XEBEC SYSTEMS INC			
SCALE NONE	APPROVED BY:	DESIGNED BY: SV	REVISION:
DATE: 3-24-71	<i>C. H. H.</i>		
NOVA COUPLER			
DATA CHANNEL CONTROL 1 OF 7	SHT. 100518 E	GRADING NO.

HEBEC SYSTEMS, INC. 519 San Xavier, Sunnyvale, California	ENGINEERING CHANGE NOTICE	PRODUCT XMD 5000	SHEET 1 OF 1	ECON. NO. 193
--	---------------------------	---------------------	-----------------	------------------

XEBEC SYSTEMS, INC. 595 San Xavier, Sunnyvale, California	ENGINEERING CHANGE NOTICE	PRODUCT NOVA COUPLER	SHEET 1 OF 1	ECN NER. 204
--	---------------------------	-------------------------	-----------------	-----------------

XEBEC SYSTEMS INC			
SCALE: NONE	APPROVED BY:	DRAWN BY: S.V.	
DATE: 3-27-71	<i>C. Jensen</i>	REVISED	
NOVA COUPLER			
BUFFER CONTROL		SMT. DRAWING NO. 2 OF 7 100518 E

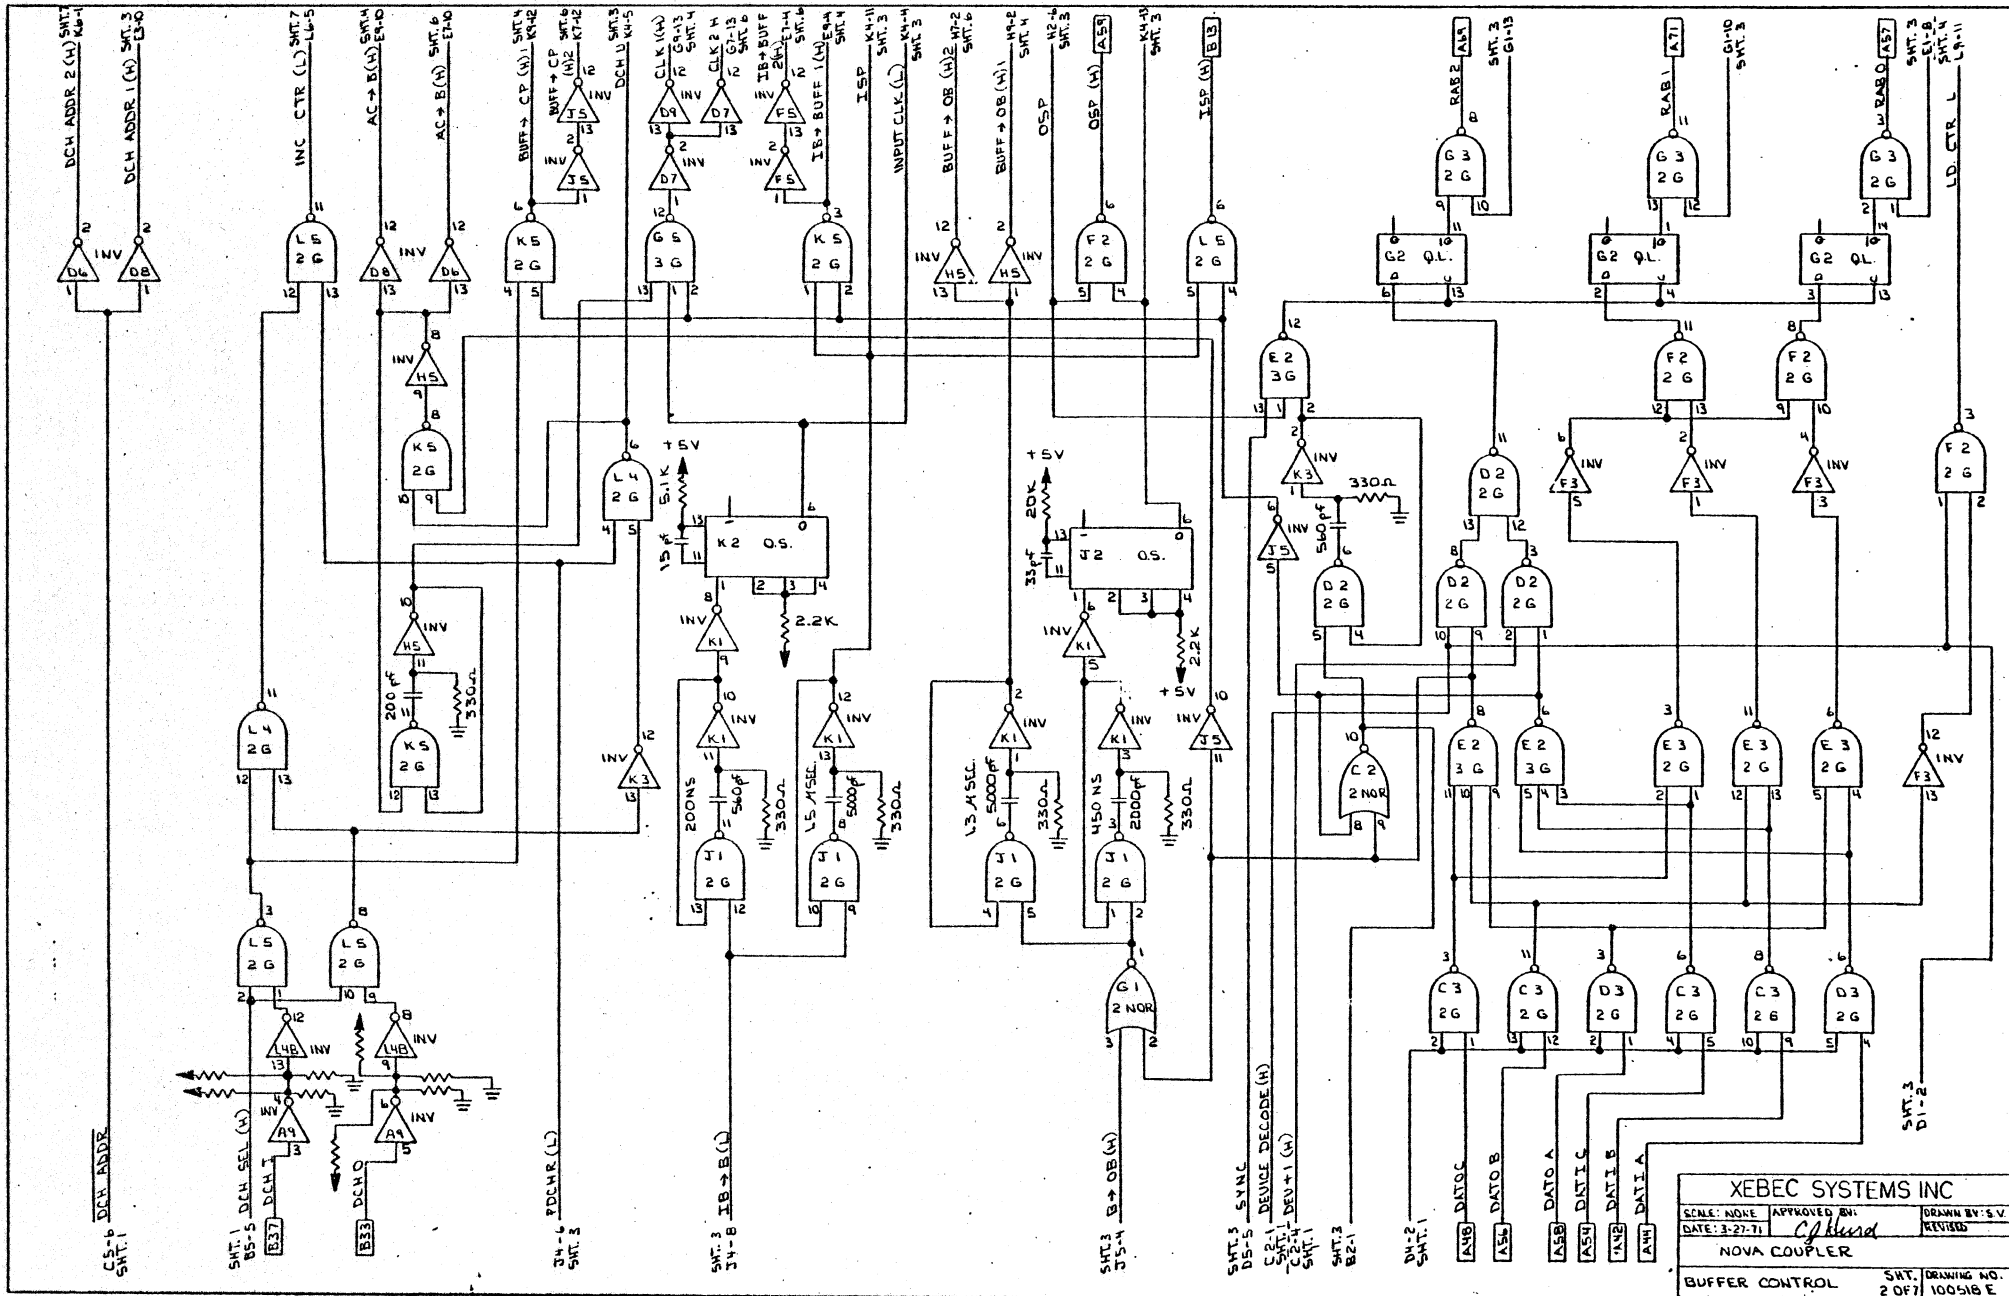
REASON FOR CHANGE: TO SYNC. BUFFER TO CPU TIMING IN WRITE MODE BY USING DCHO AS BUFFER CLOCK.	XPN 100518	AFFECTS REV. D	NEW REV. E	TITLE NOVA COUPLER	FIELD CHANGES REQUIRED: 800's ONLY
	OTHER DRAWINGS AFFECTED: DWG. NO. SHT. TYPE		MFG'G INSTRUCTIONS:		
INTERCHANGEABILITY AFFECTED FIT? FUNCTION?	100518		LOGIC	UPDATE ALL CARDS IN STOCK, TEST AND IN PROCESS.	
	100519		ARTWORK

CUT - K4-5 TO K5-10
G5-12 TO D7-1
D7-2 AT CHIP.

ADD - G1-4 TO D7-13
G1-6 TO G5-12
G1-5 TO L4.5-2
L4.5-1 TO L4-6
K5-10 TO L4.5-4
L4.5-3 TO J4-2

KELCO SERVICES, INC. 545 San Xavier, Sunnyvale, California		ENGINEERING CHANGE NOTICE			PRODUCT Nova Coupler	SHEET 1 of 1	FIGURE 484	
REASON FOR CHANGE: Improve timing.	EFFECTS REV		NEW REV	TITLE		FIELD CHANGES REQUIRED: A/R		
	100518		H	J	Nova Coupler			
	OTHER DRAWINGS AFFECTED:		MFG'G INSTRUCTIONS:					
DWG. NO.		SHT. TYPE		ALL production				
100518-E		2,3 logic						
Assy Drawg		Rev. J						
INTERCHANGEABILITY AFFECTED								
FIT? FUNCTION?

1. Change value of cap at J1-3 from 2000pf to 1000pf.
2. Change value of cap at L3-8 from 5000pf to 910pf.

Improve tuning

1. Change value of cap. at J1-3, to 330 (390) pfd
2. Change value of resistor at J2-13 from 20K to 15K
3. Change value of cap. at J1-6 to .002 ufd.

REASON FOR CHANGE: TO COMPENSATE FOR NOVA 2/10 VOLTAGE CHANGES DUE TO CHASSIS LOADING.	XPN 100518	AFFECTS REV K	NEW REV L	TITLE NOVA INTERFACE	FIELD CHANGES REQUIRED: A/R ALL MARTIN WOLFE
	OTHER DRAWINGS AFFECTED:			MFG'G INSTRUCTIONS:	
	DWG. NO.	SHT. TYPE			
	100518	2	LOGIC	ADD THIS COMPONENT CHANGE TO ALL PRODUCTS BEFORE SHIPMENT.	
	100518	1	MATL LIST		
	100518	1	ASSY.		
INTERCHANGEABILITY AFFECTED FIT? FUNCTION?

CHANGE RESISTOR VALUE AT J2-13 FROM 15K 1/4 WATT TO
 10K 1/4 WATT, THIS WILL SHORTEN OSP WIDTH AND ALLOWS MORE
 TOLERANCE WITH RESPECT TO BUFF. TO OB.

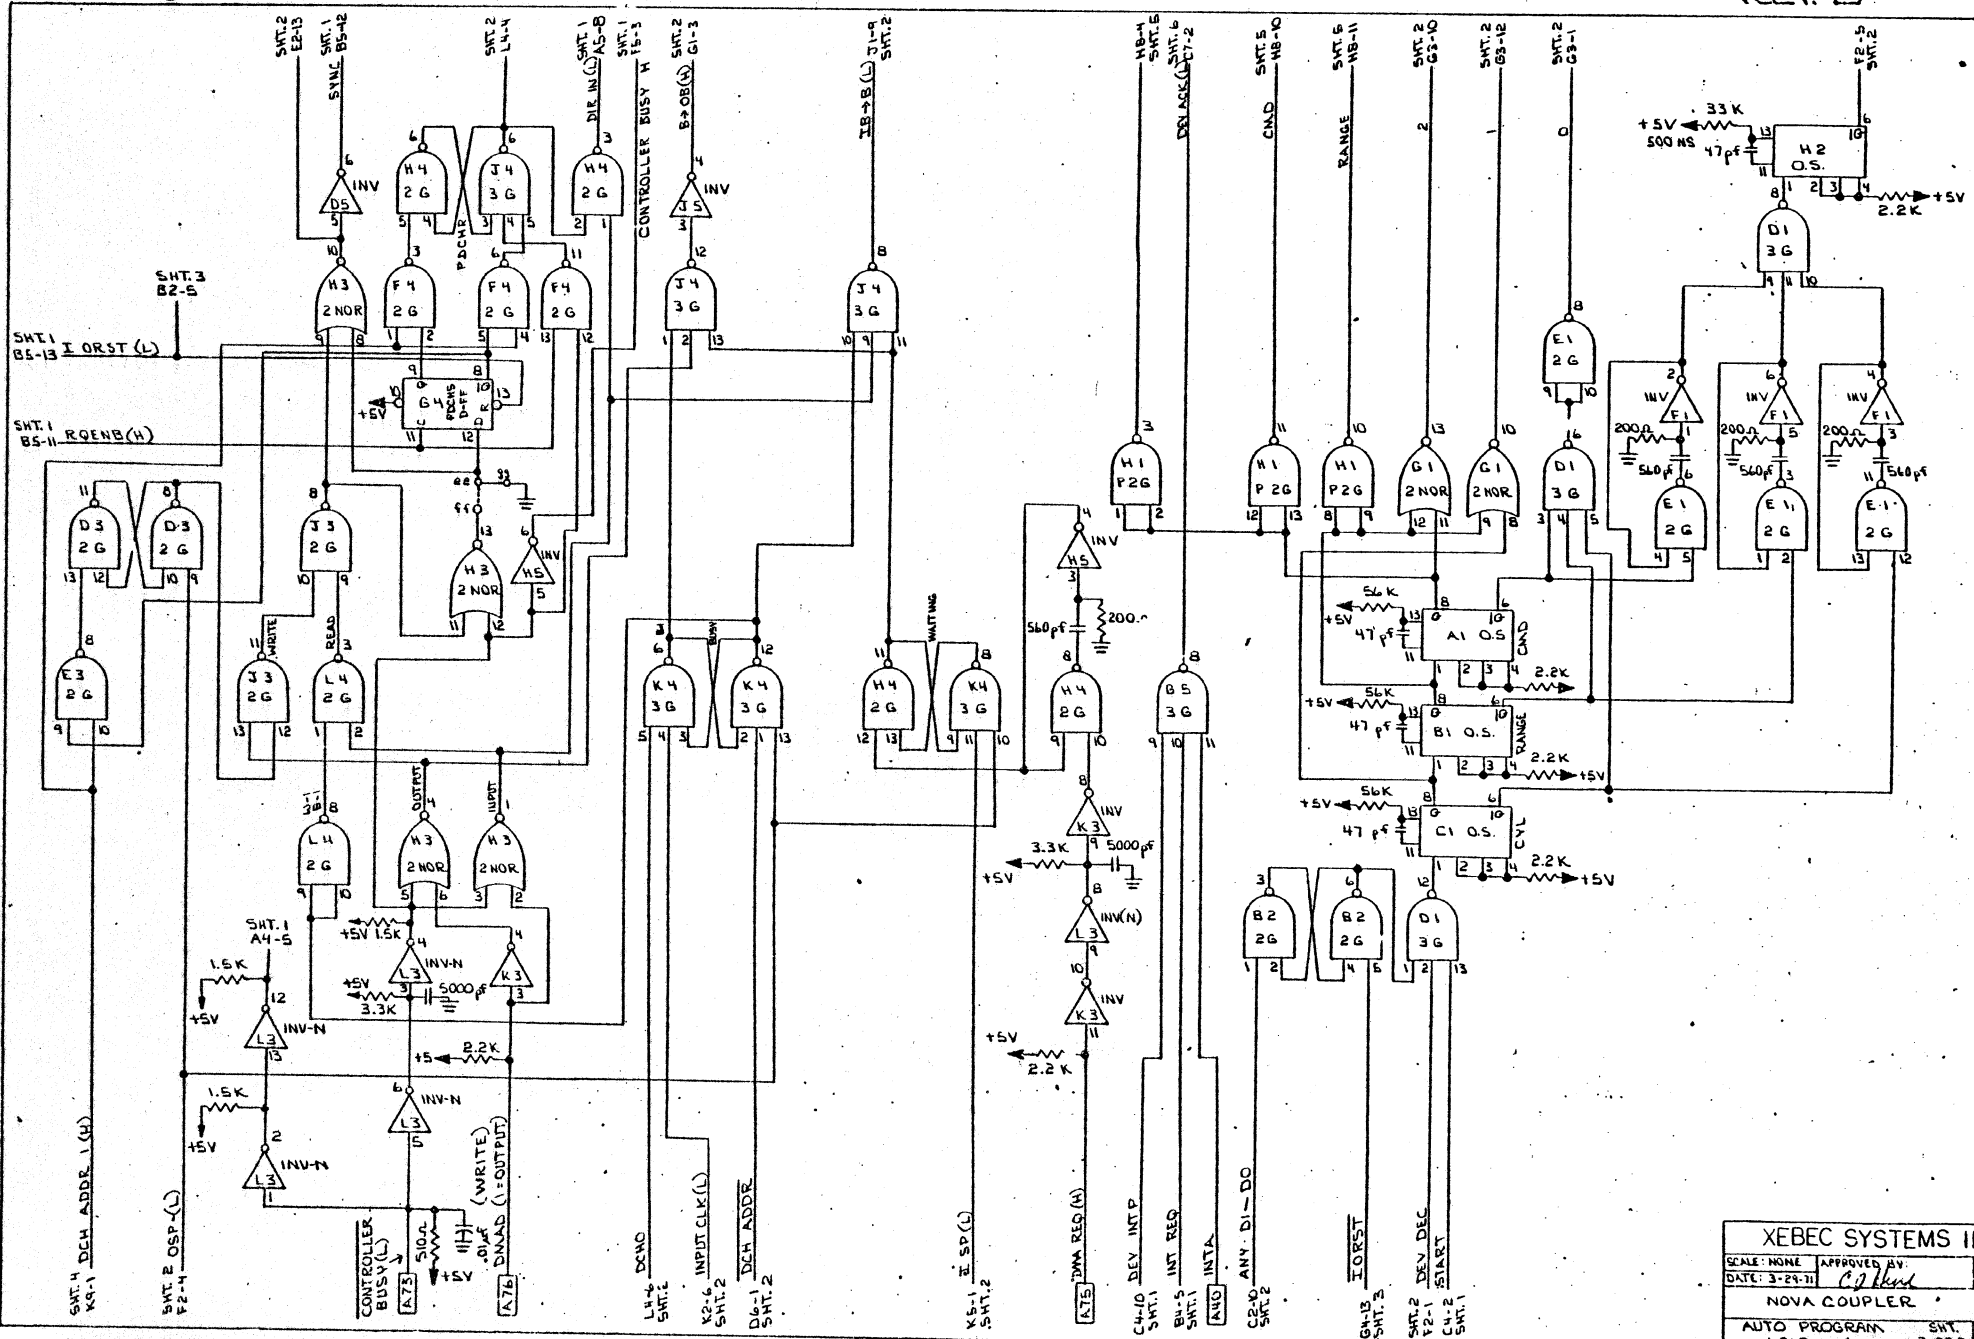
REASON FOR CHANGE: SAME AS ECN #179. NOW ALL P.C. BOARDS AFFECTED. TIMING RACE BETWEEN FIRST DMA AND RAB'S DURING READ OPERATION.	XPN 100518	AFFECTS REV. E	NEW REV. F	TITLE NOVA COUPLER	FIELD CHANGES REQUIRED:
	OTHER DRAWINGS AFFECTED: DWG. NO. SHT. TYPE		MFG'G INSTRUCTIONS: REWORK ALL BDS. IN STOCK, TEST AND IN PROCESS.		
INTERCHANGEABILITY AFFECTED FIT? FUNCTION?		100518 100519 100518	2,3 LOGIC ARTWORK ASSY.

1. CUT TRACE AT FEEDTHROUGH OFF E2-13 (COMP. SIDE)
2. ADD WIRE FEEDTHROUGH OFF E2-13 TO K3-10.

REASON FOR CHANGE: ILLEGAL TO PREVENT DNA TRANSFER WHEN USING AUTO PROG. LOAD.	XPN	AFFECTS REV	NEW REV	TITLE	FIELD CHANGES REQUIRED: INSTALL WHERE AUTO LOADING USED
	100518	F	G		
	OTHER DRAWINGS AFFECTED:		MFG'G INSTRUCTIONS:		
	DWG. NO.	SHT. TYPE	INSTALL IN ALL -518 BDS.		
	100518	3 LOGIC			
	100519	2 ART/DRK			
OTHER CHANGES AFFECTED FUNCTION?

MFG:
 CUT K4-10, 13 AFTER FEED THRU (BACK SIDE BETWEEN 3 & 4)
 CUT D3-9 " " " (BACKSIDE BETWEEN 3 & 4)

ADD K4-10, 13 TO D3-9 TO J3-3
 F2-6 TO J3-1 & 2
